19 August 2014

Our Ref: 2014/317252-01  
File No: S048710

**RE: Response to submissions for State Significant Development Proposal (SSD 6092) for Block 8 and Section 75W Application for Project Application MP06\_0171 (MOD 9) for Concept Plan at Central Park, Chippendale (former Carlton United Brewery site)**

**Figure 1:** Level 10 of PPR showing amenity conflicts between apartments.

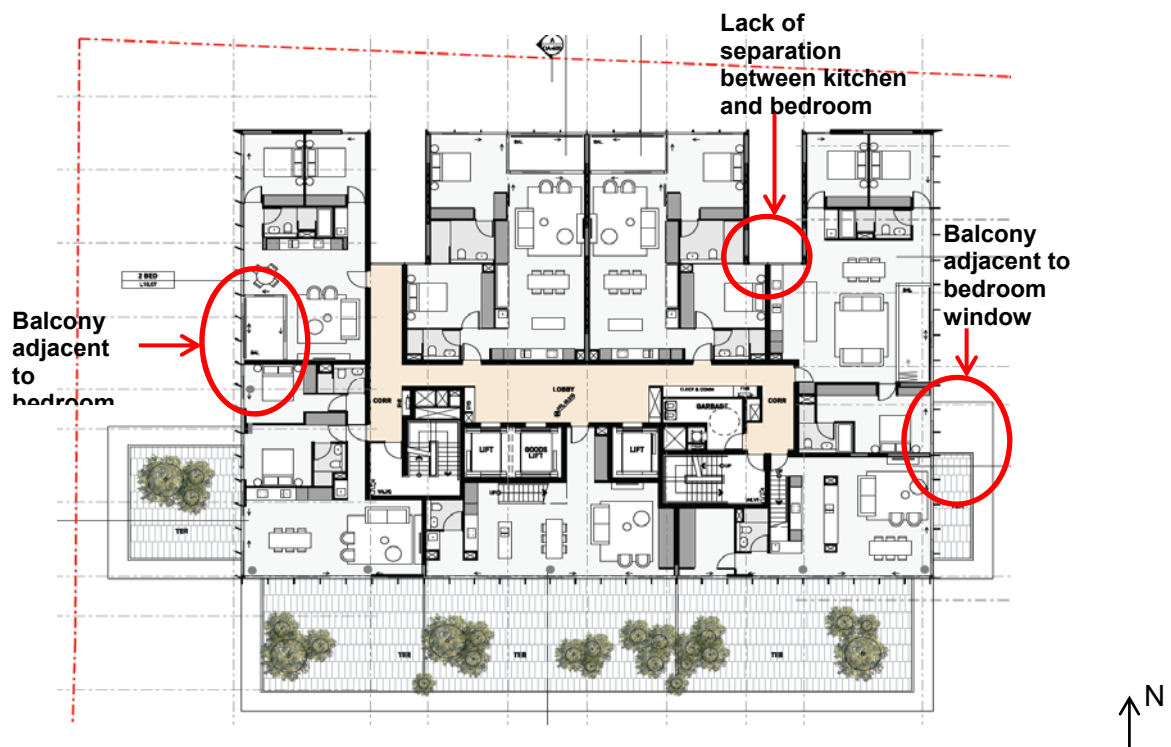
For example, the diagram below shows the location and proximity of window openings and private open spaces of adjacent apartments. The highlighted areas are likely to result in poor visual and acoustic privacy for future occupants. As per the City's previous comments it is not appropriate to have openings to principle living areas or private open spaces of one apartment immediately adjacent to quiet habitable spaces of another apartment.

In this instance, the proposed blades on the eastern and western facades are unlikely to provide sufficient acoustic or visual privacy to bedrooms particularly if windows are opened for natural ventilation.

The proponent should be required to review all apartment layouts within the development to ensure that the design adequately reduces loss of privacy and amenity for future occupants.
